HIGHCREST SUBDIVISION, UNIT 1, RESUBDIVISION OF LOTS 88 & 89

APPLICATION NUMBER 11 DATE September 6, 2007

DETAIL SITE PLAN

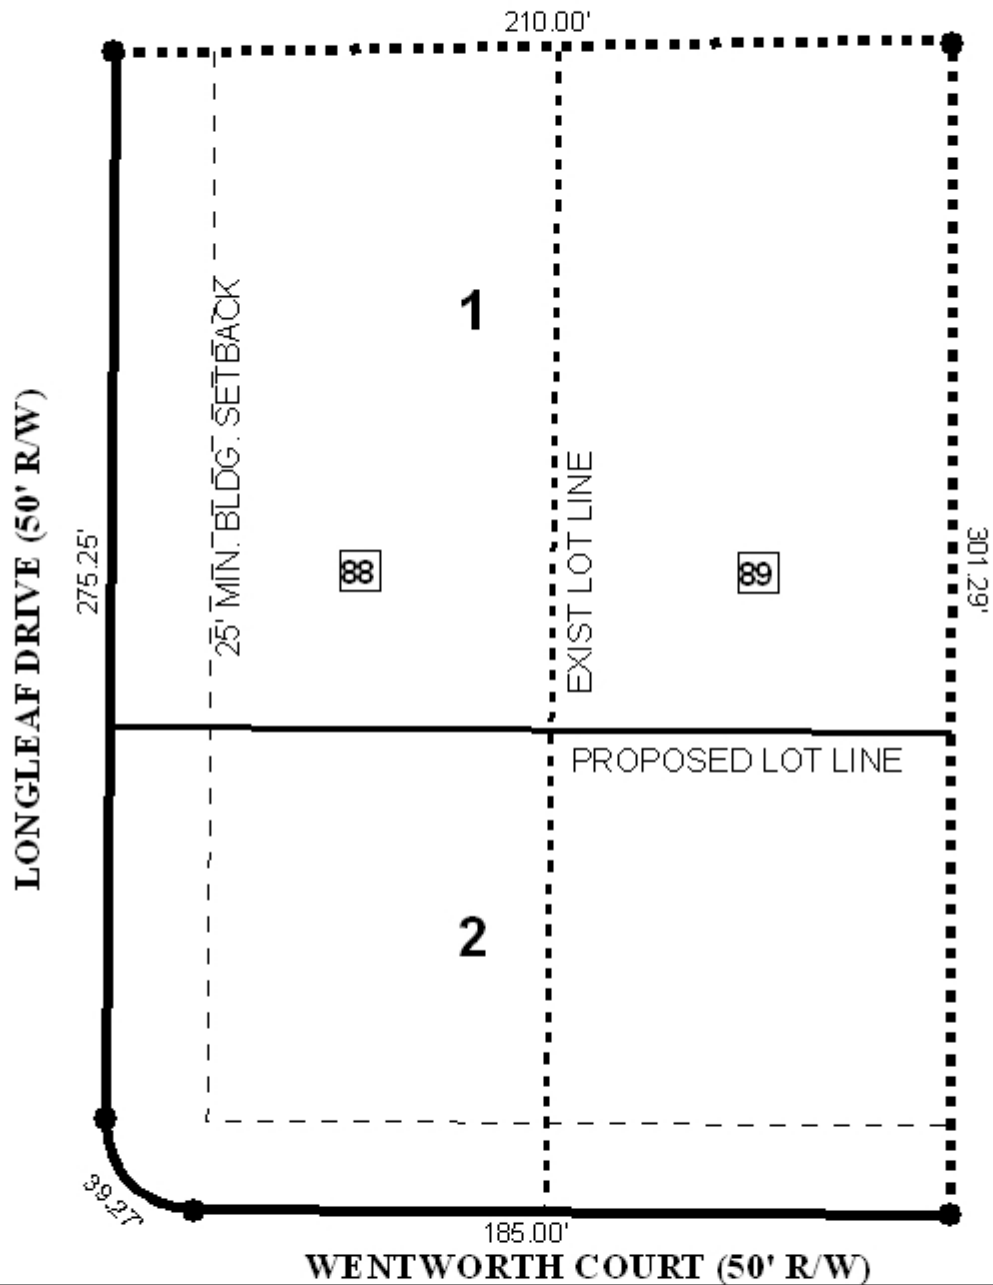
The site fronts Wentworth Court and Longleaf Drive, both of which have 50' rights-of-way. Right-of-way widths and corner radius are consistent with Section V. of the Subdivision Regulations. The plat illustrates the required 25' minimum building setback line along both street frontages, and this should also be depicted on the final plat.

There are no lot sizes indicated on the plat; therefore, the plat should be revised to label each lot size in square feet, or a table should be provided with the same information.

Each lot should be limited to one curb cut, with the size, design, and location to be approved by Traffic Engineering and conform to AASHTO standards.

1. depiction of the 25' minimum building setback line along both street frontages on the final plat;
2. revision of the plat to label each lot with its size in square feet, or provision of a table on the plat depicting the same information; and

3. placement of a note on the final plat stating that each lot is limited to one curb cut, with the size, design, and location to be approved by Traffic Engineering and conform to AASHTO standards; and
